UNITED STATES PATENT AND TRADEMARK OFFICE

APPLICATION NO.	FILING DATE	FIRST NAMED INVENTOR	ATTORNEY DOCKET NO.	CONFIRMATION NO.
10/671,928	09/26/2003	Kouji Imai	21334-1259	8294
29450	7590	02/23/2006		
BARLEY SNYDER, LLC 1000 WESTLAKES DRIVE, SUITE 275 BERWYN, PA 19312			EXAMINER CAZAN, LIVIUS RADU	
			ART UNIT	PAPER NUMBER
			3729

Office Action Summary

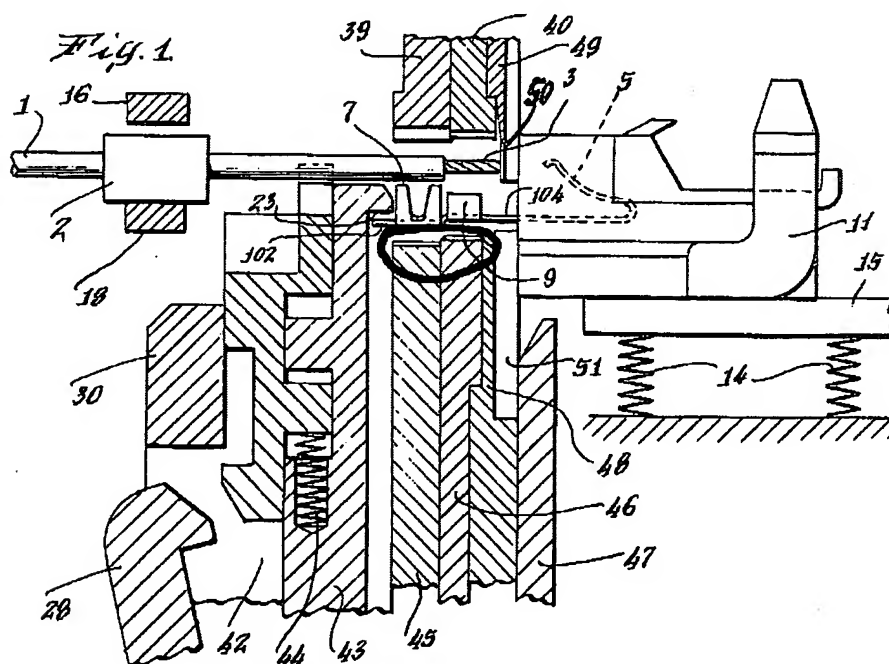
b. Regarding claim 2, (as best understood), Wigby et al. disclose the same invention as the applicant, including a wire termination apparatus wherein a terminal placed on an anvil and having a conductive lead inserted in an insertion hole of the terminal is crushed by a crimper, thereby terminating the conductive lead (see Fig. 2)

c. Regarding claims 3 and 4, Wigby et al. disclose the same invention as the applicant, including a guide member operatively associated with a crimper such

that the guide member is caused to retreat from a component during the downward motion of the crimper, before the crimper abuts the terminal. See In. 50 of col. 3 to In. 11 of col. 4; see col. 4, Ins. 40-47; in order to make allow the various components to move relative to each other, they are actuated (and linked) by connected rods interconnected with cams; see *Howstuffworks "Inline Four-Cylinder Engine"* for a clear understanding of how connecting rod mechanisms operate. Since the step shown in Fig. 2 the guide 42 moves away from the component (wire) and crimp blades 39 and 40 move downward, and since a connecting rod mechanism is employed, it is deemed inherent that some degree of movement of guide 42 away from the wire will occur as the crimp blades begin to descend.

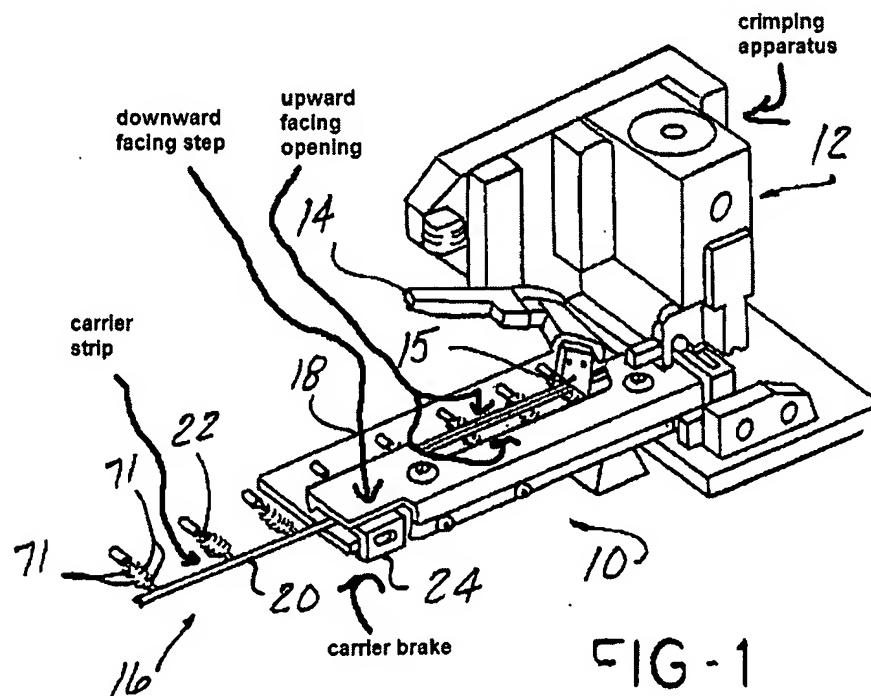
Fukase teaches these limitations (see discussion in part **14b** above, regarding claim 9), wherein a large diameter portion (6 in Fig. 3) of a component is not allowed to enter a crimping area of a crimping machine by abutting against the positioning plate (portion 28 of late 27 in Fig. 3) and wherein an escape groove in the plate allows for movement of a conductive lead during a termination operation.

Therefore it would have been obvious to one of ordinary skill in the art at the time the invention was made to modify the apparatus of Wigby et al., in view of the teachings of Fukase, by adding such a positioning plate, in order to allow only the part of the

component which should be crimped to enter the crimping area of the machine and in order to allow movement of a conductive lead during termination.
